Re: Kings Basin Water Authority Comments Regarding the 2015 Implementation Grant Solicitation Draft Funding Recommendations

Kings Basin Water Authority
CID: Adams & Academy Basin
Figure 2-2: Project Map
2015 IRWM
Implementation Solicitation

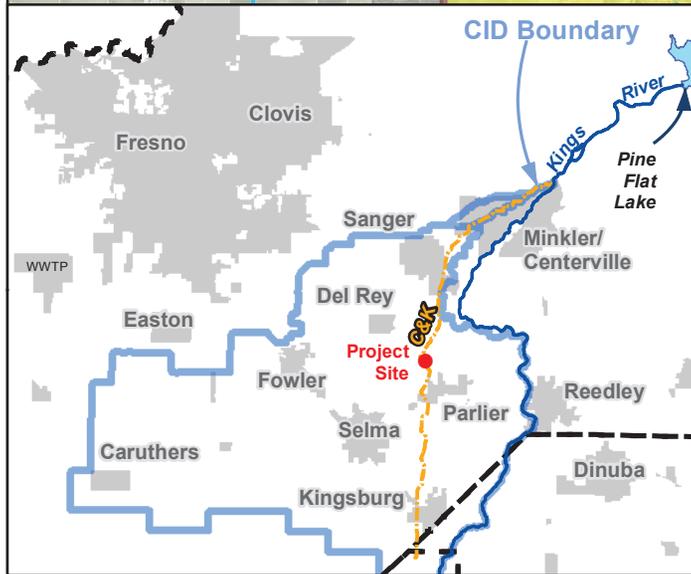
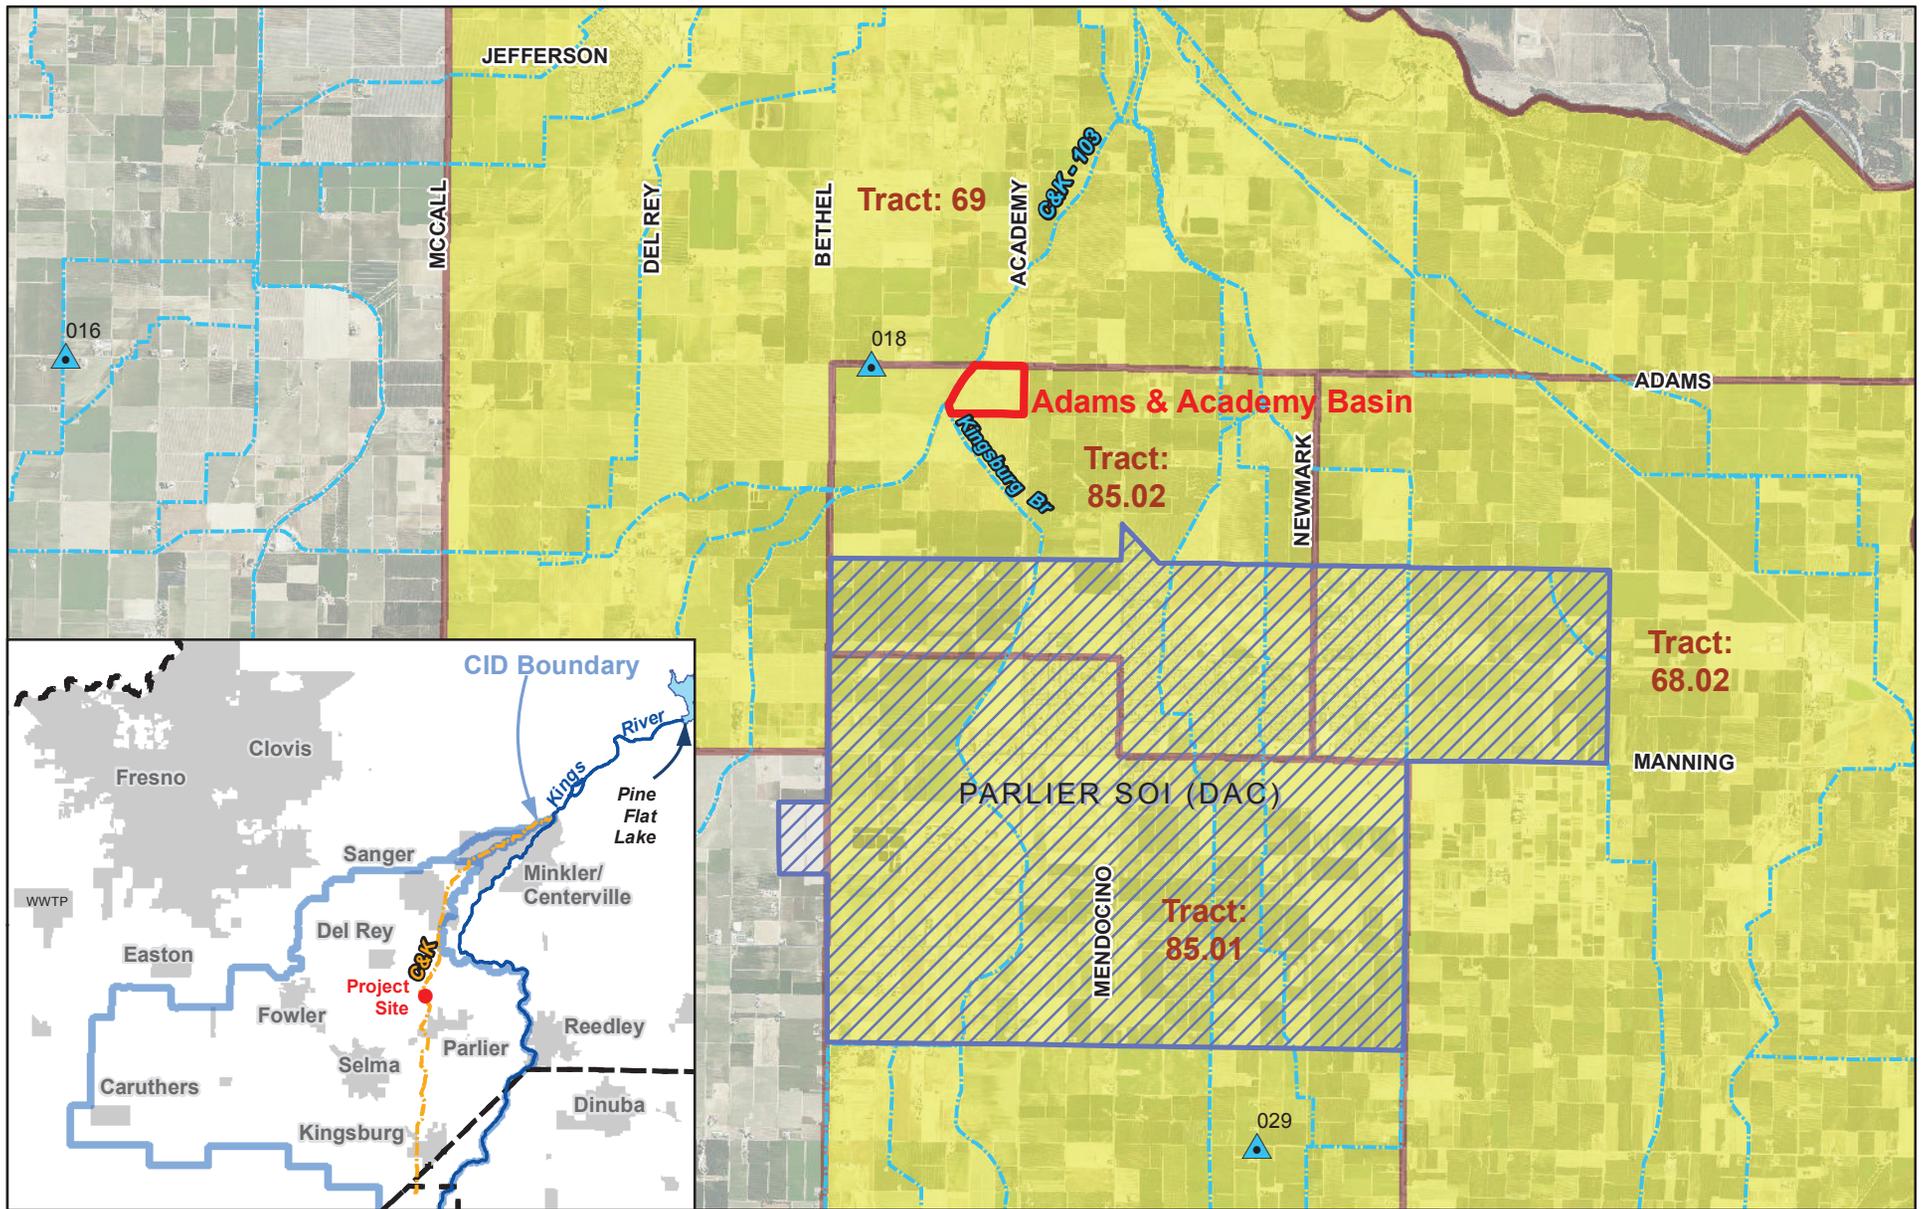
- Both Figures 2-2 and 7-1 (attached unchanged as submitted in the application) show a map of the project area, and clearly show the yellow area as DAC, including the City of Parlier and surrounding area. From just a visual inspection of these maps, it is clear that more than 25% of the project area is a DAC.

- Map figure 2-2 shows an extent of more than 5 miles down gradient from the basin, well beyond the expected movement of the recharged water at the basin site. It should be understood that the recharge benefit will not extend beyond the area shown within the extent of these figures. However, if there was a question about the extent of the migration of recharged water from the basin, included within the application was sufficient detail to verify the extent of the recharge benefit area. The Feasibility Study for the project was included as Attachment 3b, and within that feasibility study, a mounding calculation (Table 2 on page 3-5 of the feasibility study and included below) showing the extent of the mounding from the basin to be less 2ft at just over one mile from the basin, clearly within the limits of the project area maps provided.

- On page 2-18 under the Direct Water-Related Benefit to a DAC section, it is stated that "The project will provide recharge to Parlier as well as the area surrounding the basin which is also a DAC as shown in Figure 2-2." Later in that section, it goes on to say, "Groundwater flow in the area of the proposed basin is in the direction of Parlier and its sphere, so the recharged water will benefit Parlier and the nearby area." These statements make it clear that the recharge benefit of 2,268AF/yr goes to the DAC, as shown in Figure 2-2. It would seem that the application was marked "No" because the application did not state "100%" of the recharge benefit will benefit Parlier and the nearby area. As listed above, the application states "the" recharge benefit, which by definition means 100% of the recharge benefit.

- The water extracted will be delivered to the surrounding area (as stated on page 7-1) shown on Figure 2-2. Although not part of your explanation during our conference call, if there was a question regarding the amount of groundwater being extracted reducing the overall recharge benefit to the project area, it was clearly stated throughout the application that groundwater extraction amount is limited to 1,320Af/yr, leaving the difference (948AF/yr or 41.7%, well above the 25% threshold) in the aquifer around the basin. However, as stated, the entire benefit (recharge and extracted water) serves the DAC, including the water extracted that is delivered to the landowners in proximity to the basin.
